**CITY OF TEMPE
DEVELOPMENT REVIEW COMMISSION**

Meeting Date: 03/24/2015
Agenda Item: 2

ACTION: Request for a Development Plan Review consisting of two new apartment buildings containing 19 units, one Use Permit to allow tandem parking, and one Use Permit Standard to increase the maximum building height from 30' to 32' for 5TH & HARDY APARTMENTS, located at 1000 West 5th Street. The applicant is Anthony Miachika, Pacific Rim Property Investments Ltd.

BACKGROUND INFORMATION: 5TH & HARDY APARTMENTS (PL140327) will consist of two, three-story apartment buildings containing 19 units with both tandem and side-by-side garage parking. These cases were heard at the February 24, 2015 Development Review Commission hearing and continued by the Commission to allow the applicant to address issues related to the elevations, material samples, and tandem parking request. The request includes the following:

Building 'B' West Elevation

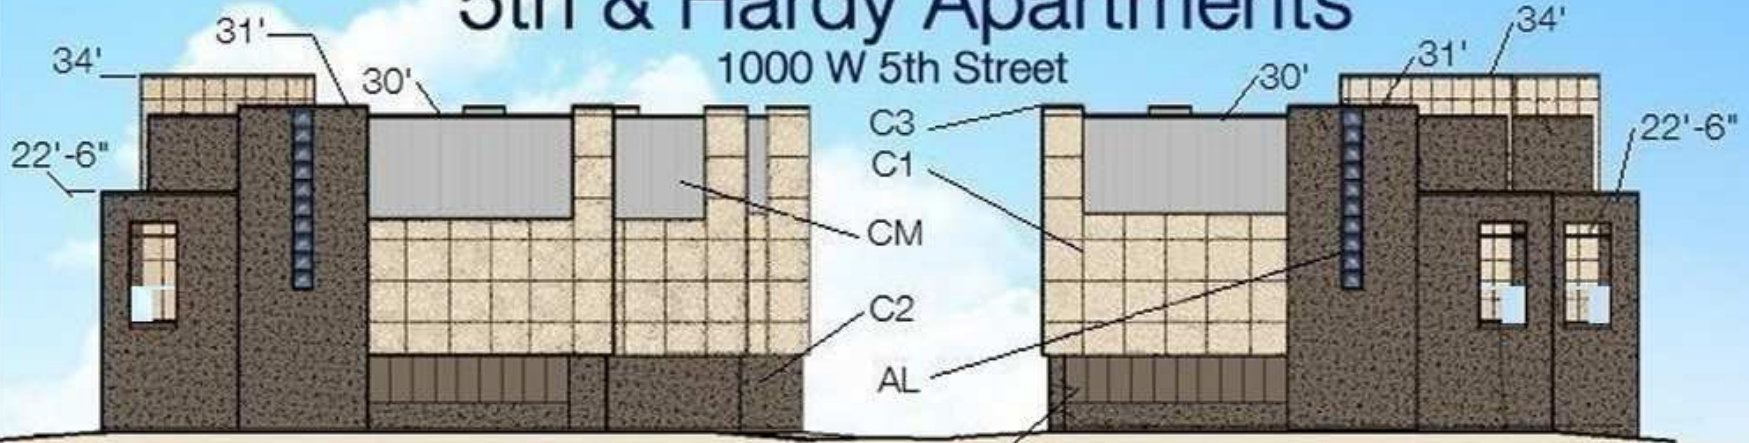
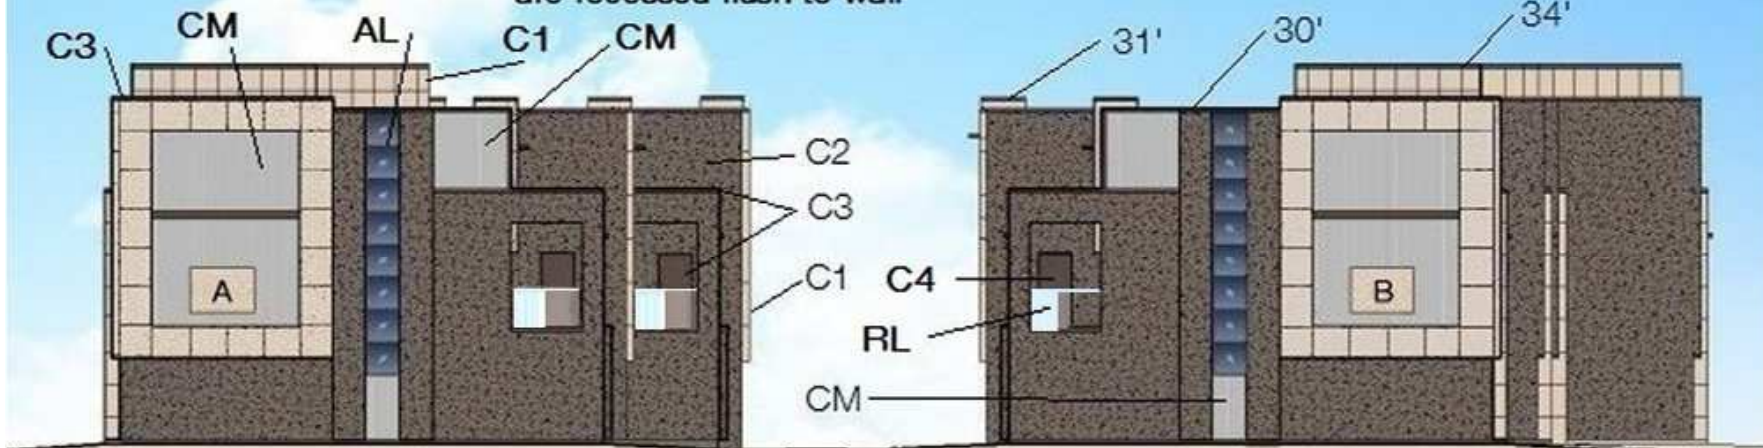
9. Where corrugated metal shares the same wall plane as stucco finishes, the metal shall be flush with the adjacent stucco walls.
10. The west elevations shall be modified to make all sides of the service entrance section (S.E.S.) flush with the adjacent wall.
11. All glass used on front doors and patio railings shall be laminated.
12. Provide secure roof access from the interior of the building. Do not expose roof access to public view.
13. Conceal roof drainage system within the interior of the building.
14. Incorporate lighting, address signs, and incidental equipment attachments (alarm klaxons, security cameras, etc.) where exposed into the design of the building elevations. Exposed conduit, piping, or related materials is not permitted.
